Firmware 2.06.3 issue list:

List of bugs/improvement requests

List of workarounds – by bug number

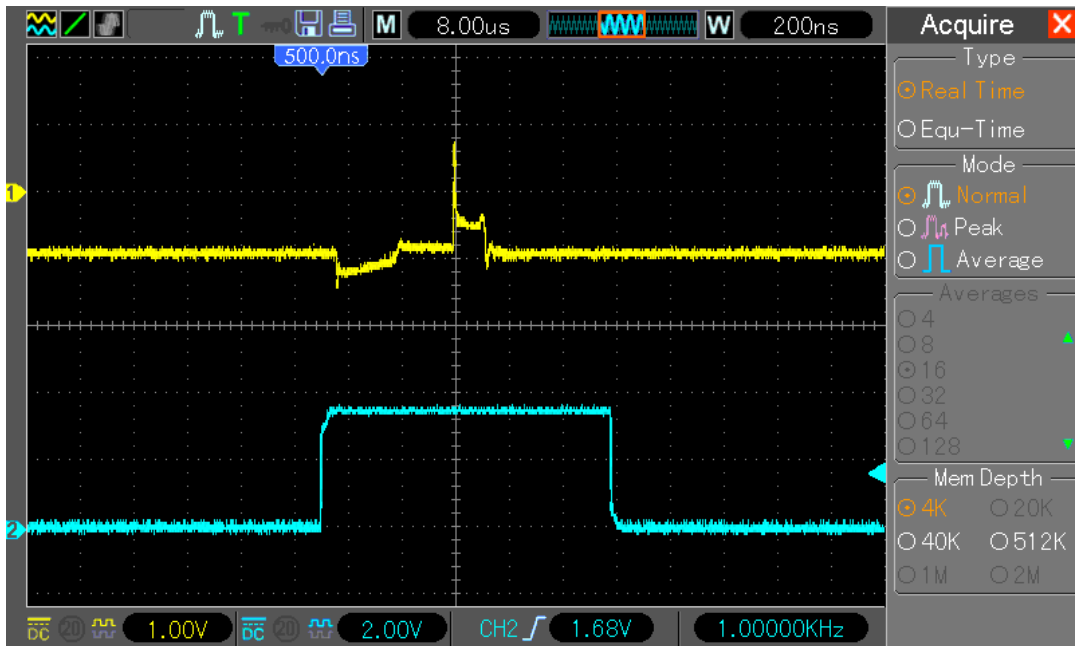
4. Digital Filters to be implemented.
5. SDK to be released
6. Update FPGA design to match ADC skew/timings in 125MHz/1GSs mode
(this is already known issue and listed in old "issue list", posting once again in this list as reminder)

FPGA design revision 83E8 sample rate 1GS/s clocks skew (**must be always 1000ps**):

FPGA design revision 83E8 sample rate <= 800MS/s clocks skew (**must be always 1250ps**):

not yet measured, but Hantek statement "*It's impossible for us to achieve it now*" is not really optimistic.

6. There is no affordable workaround for now. Changes to hardware are possible but expensive. I've tested Silicon Labs jitter cleaner, Murata LDHxxx delay lines and a combination of other solutions. I was more than satisfied with achieved results, expect the costs.
For now we have to use what available, both manufacturers developed within last 2 years few FPGA design versions, the best is from upcoming Tekway MST DSOs and Hantek Handhelds – however they not allowing dual channel 500MS/s sampling in long memory; Hantek's bench DSO hw1007 83E9 design allows such faster sampling but the skew is still far from perfect. I did publish all these FPGA designs, you can play with them to which is best for you. **But note – do not do this when you own hw1005 DSO, they can't be modified!**
For those of you who don't know what this bug means – Google for waveform/interleave distortion and/or Agilent 5989-5732EN.

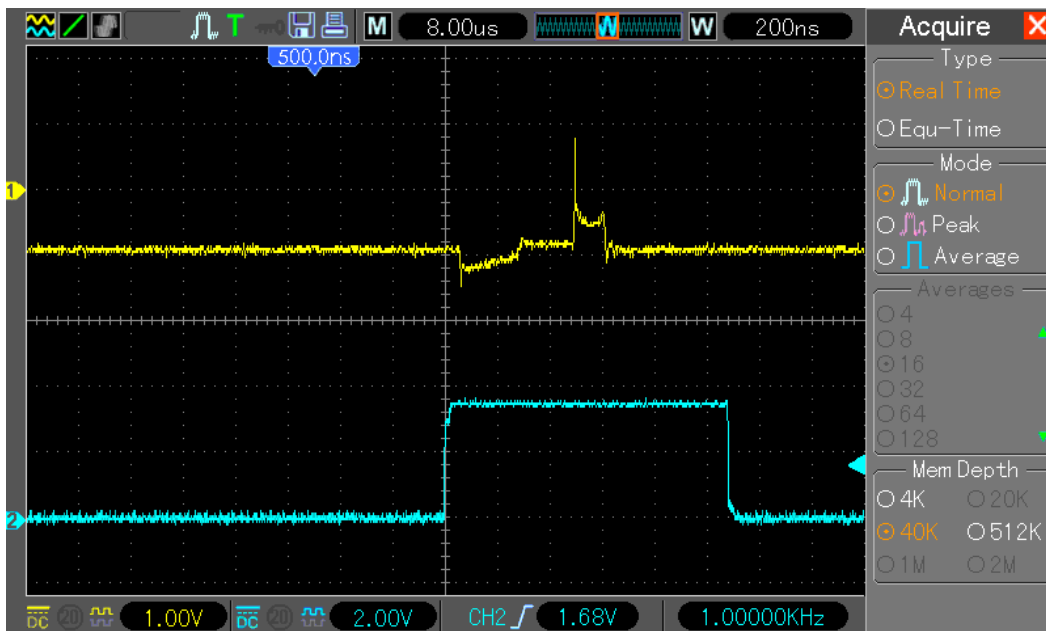
8. In single window, sample memory $\geq 40k$, both channels (ch1, ch2) enabled and time base from 400ns/div up to 2ns/div the position change (fine and coarse) control is not working. Only scale is moving, but not the waveform. See attached picture to understand issue:

with 4k memory when changing position waveform is moving

with 40k and above, when moving changing time base position waveform is NOT moving when in RUN mode (but works in STOP mode)

7. This is improvement proposal and not a bug
8. This is a very unfortunate bug; possible workaround is to use dual window mode or less memory depth (both with disadvantages)

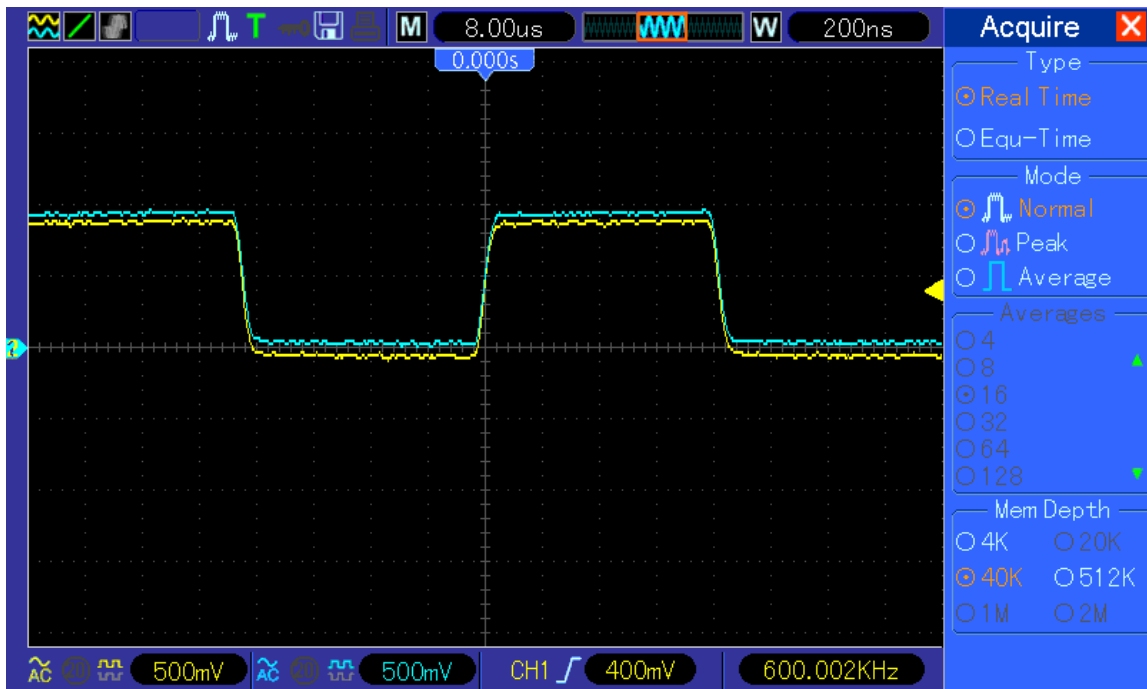
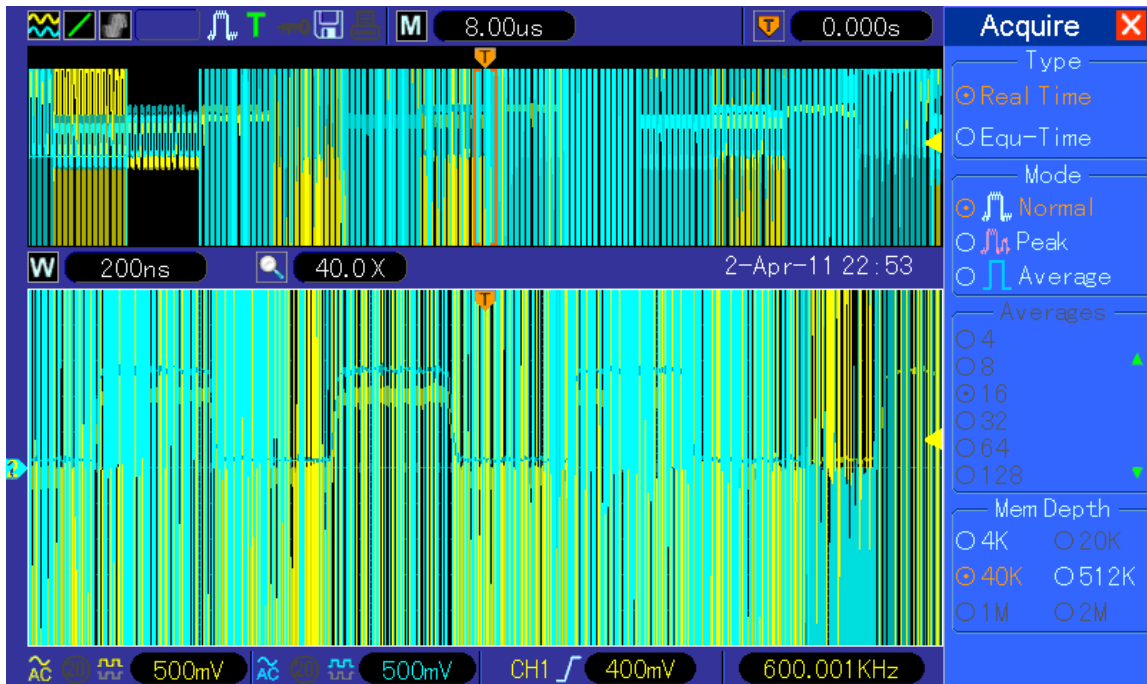
9. In single window mode, sample memory 40k, both channels (ch1, ch2) enabled – while switching to dual window mode artifacts on screen and DSO later crashing and not responding.

Artifacts disappear when changing timebase just after switch to dual window, so just an init error?

Set like on picture

and switch dual window mode to see artifacts like this:

9. Workaround is to change Timebase (just one step forward and back) right after dual window enabled. Note – the main window (top) need to be activated, the bug have something to do with main TB buffer initialization.

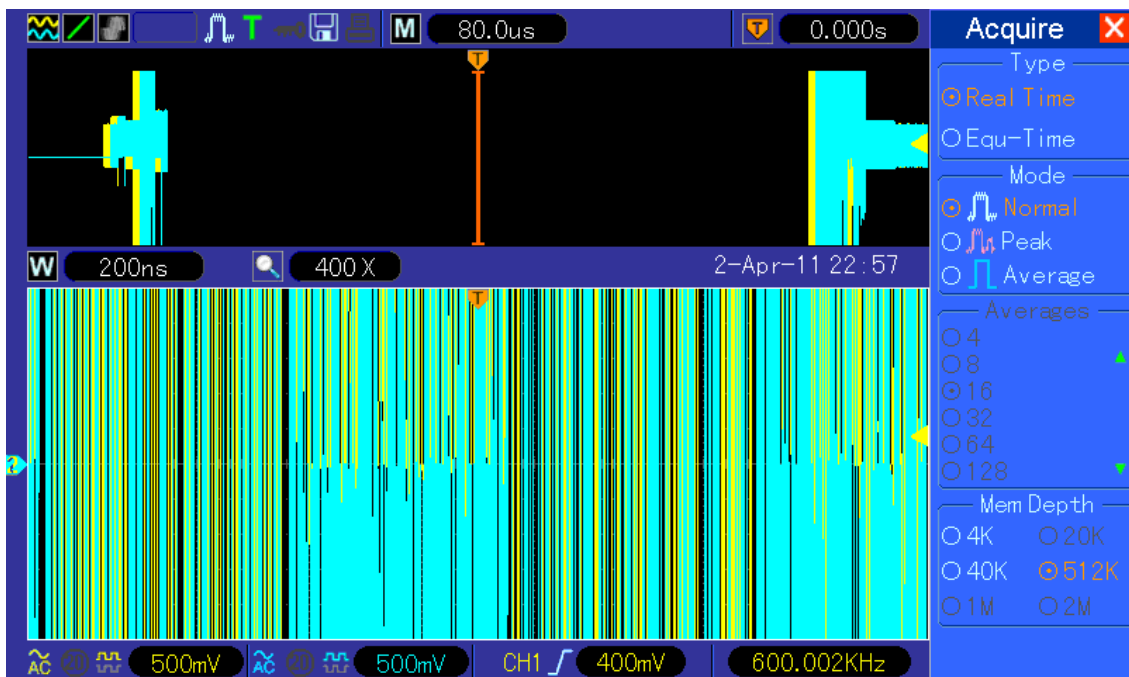
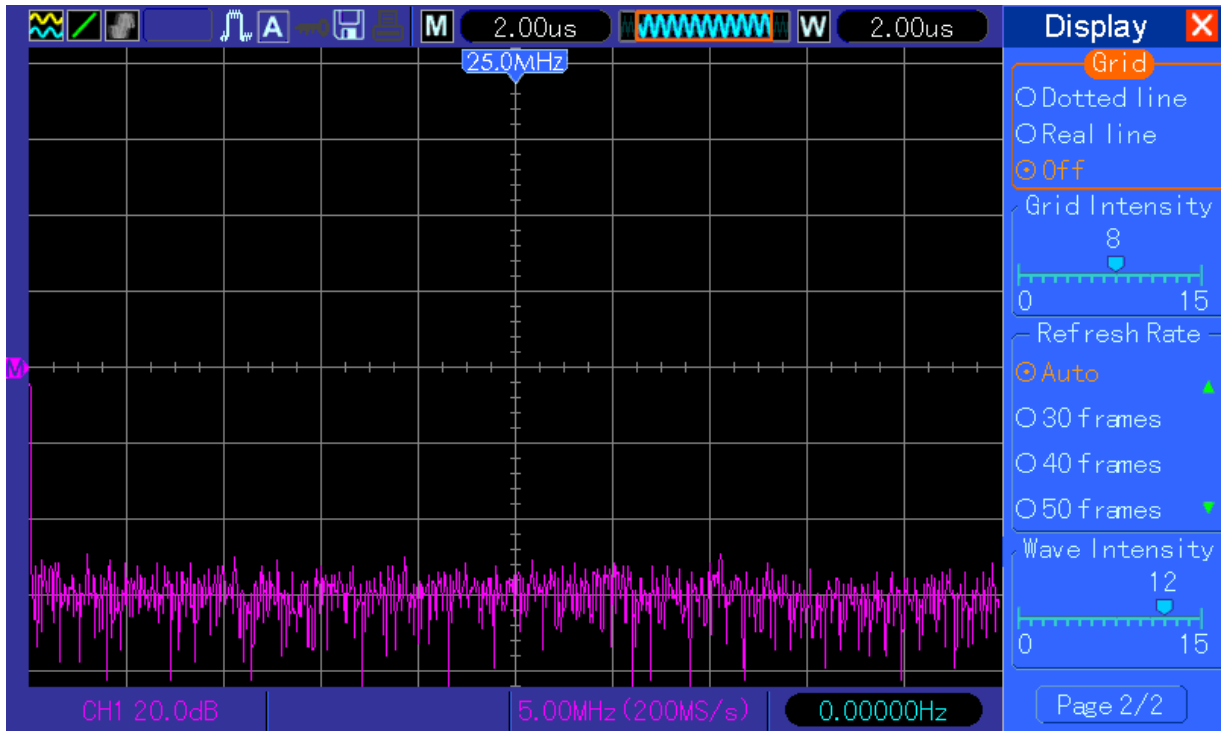
10. In single window mode, sample memory 512k, both channels (ch1, ch2) enabled – when switching to dual window mode artifacts on screen and DSO later crashing and not responding

Artifacts disappear when changing timebase just after switch to dual window, so just an init error?

Set DSO like on picture

and switch dual window mode to see artifacts like this:

10. Workaround is to change Timebase (just one step forward and back) right after dual window enabled. Note – the main window (top) need to be activated, the bug have something to do with main TB buffer initialization.

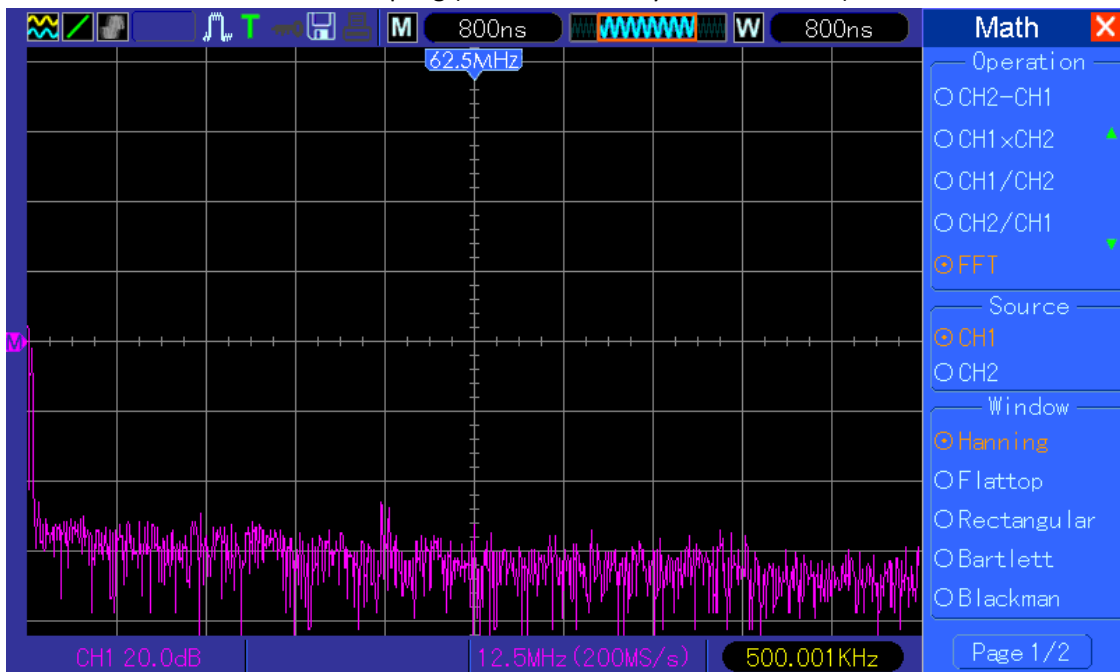
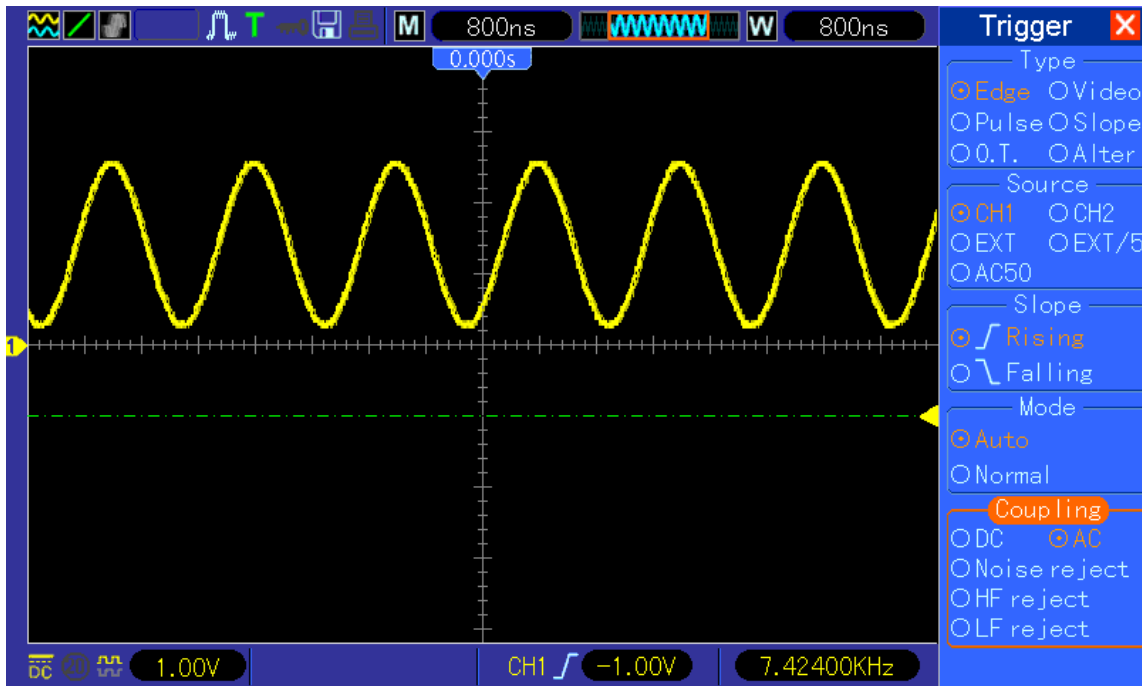
12. In FFT mode “Full span” is higher than Nyquist (sample rate / 2)

Example: 800ns/DIV, sample rate is 200MSs, full span 125MHz. Easy to fix by enabling from 800ns/DIV to 20ns/DIV 1GSs sampling (when 4k memory or FFT enabled)

11. This is improvement proposal and not a bug.
12. Use my firmware (2.06.3_120507.6), I removed that bug.
13. Use DC trigger coupling or “add offset” when you set trigger point.

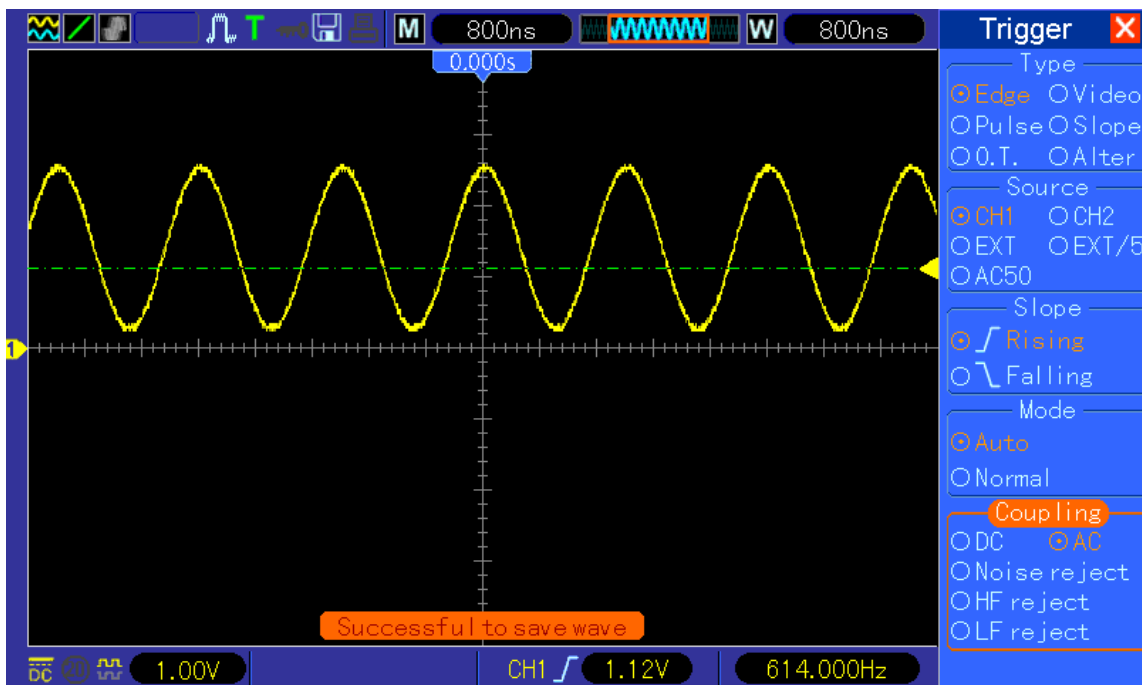
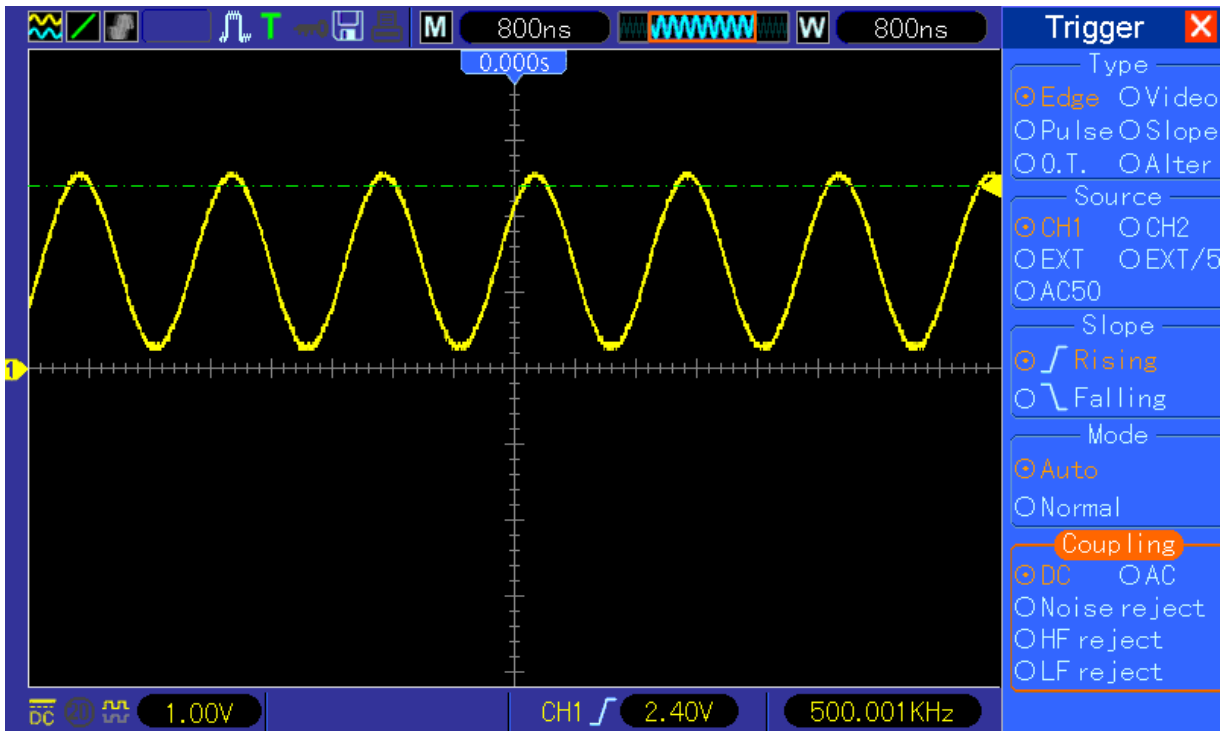
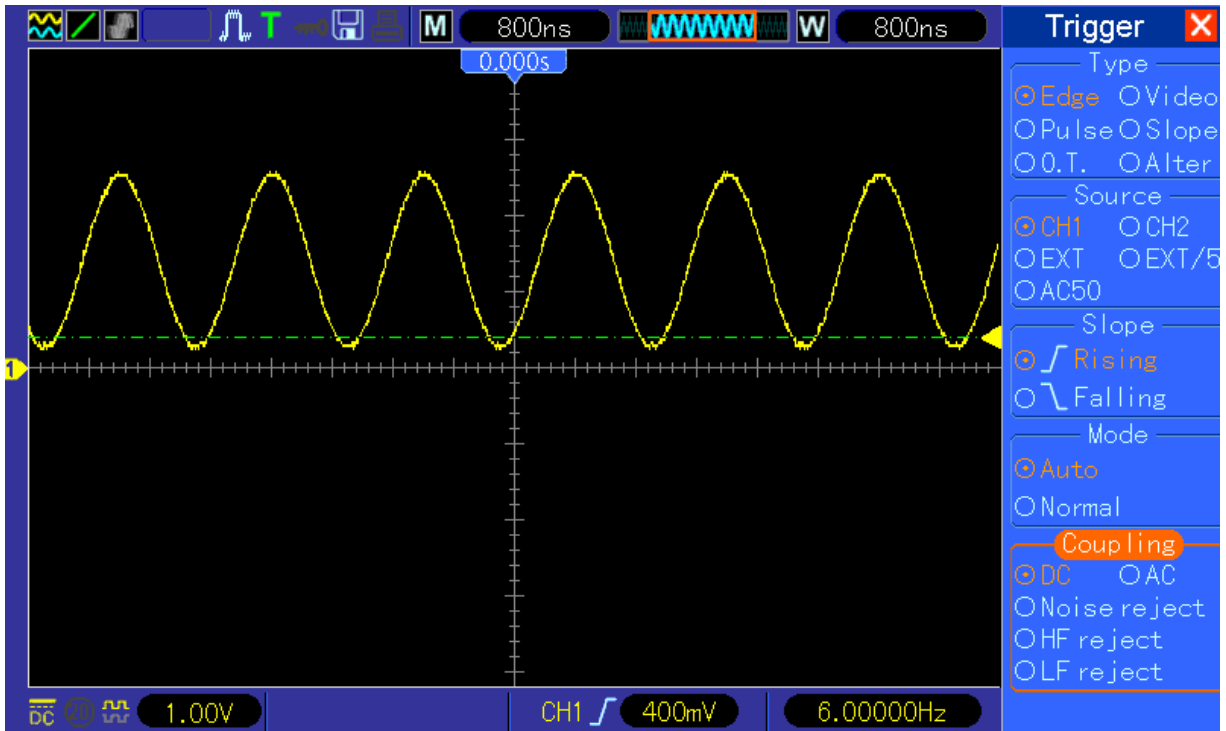
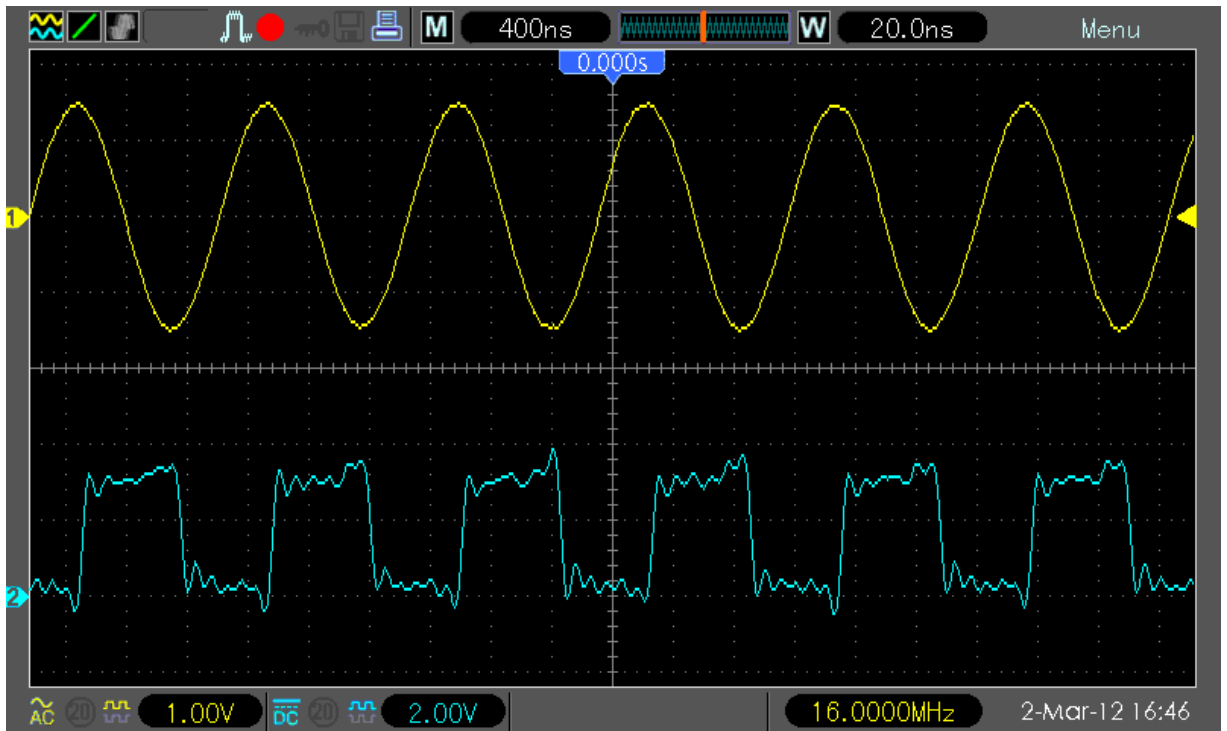
13. AC trigger indicator and line wrong. Set ch1, signal DC coupled, trigger AC coupled. The trigger lowest level below signal :

highest level only mid of signal

But both should look like when trigger coupled in DC mode:
